SB-T-06

SERVICE BULLETIN No. 06

Replacement of master switch fixation screw

Applies to all Taurus 503 aircraft up to serial number 083 T 503

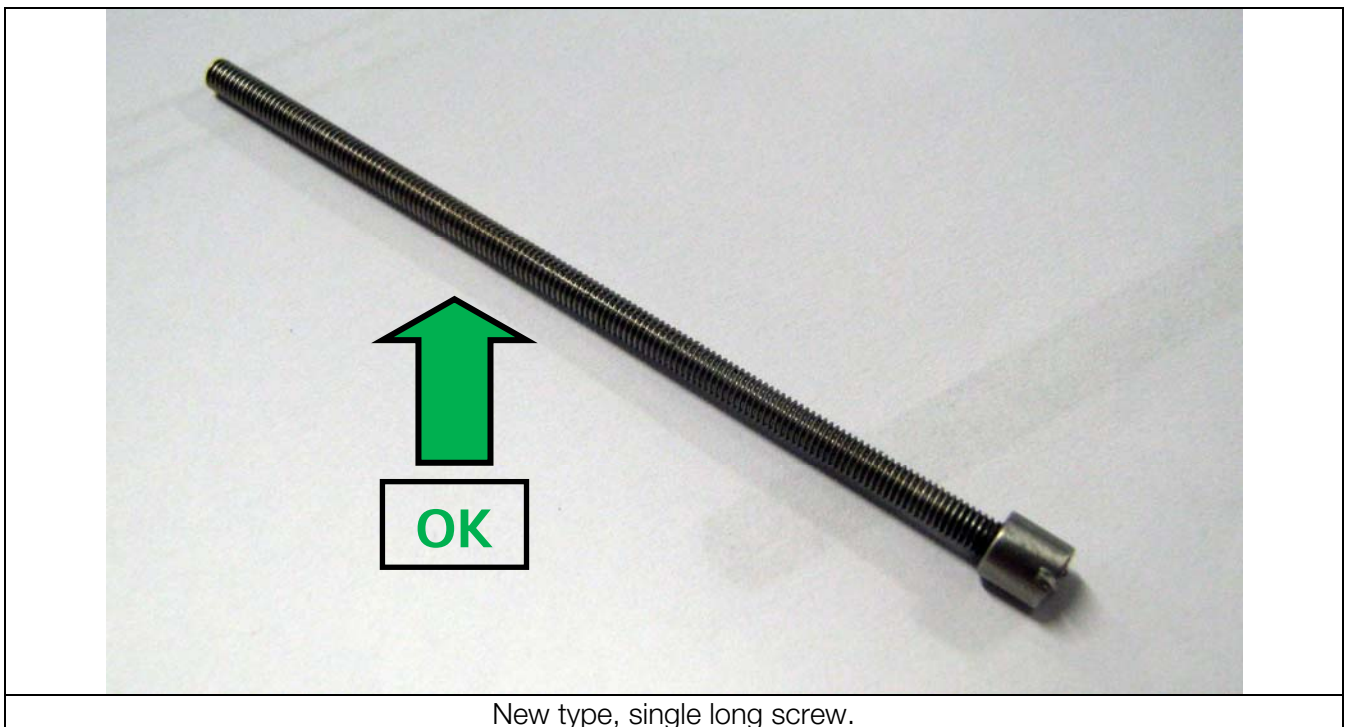
The master switch is the key-style switch on the instrument panel. Inside the instrument panel there are three elements, which make the master switch a functional unit. They are held together with a compound 3-part screw, made of three short screws attached end-to-end. In certain cases, it is possible that one or more of these short individual screws fail, causing the master switch to fail as a consequence.

Owners/operators are required to replace the compound 3-part screw (see image above) with a single, longer screw (new type).

To do this, remove the top cover of instrument column. Carefully remove the old compound 3-part screw and install the new type, single long screw into its place. Verify operation of the master switch before reattaching the top cover of instrument column.
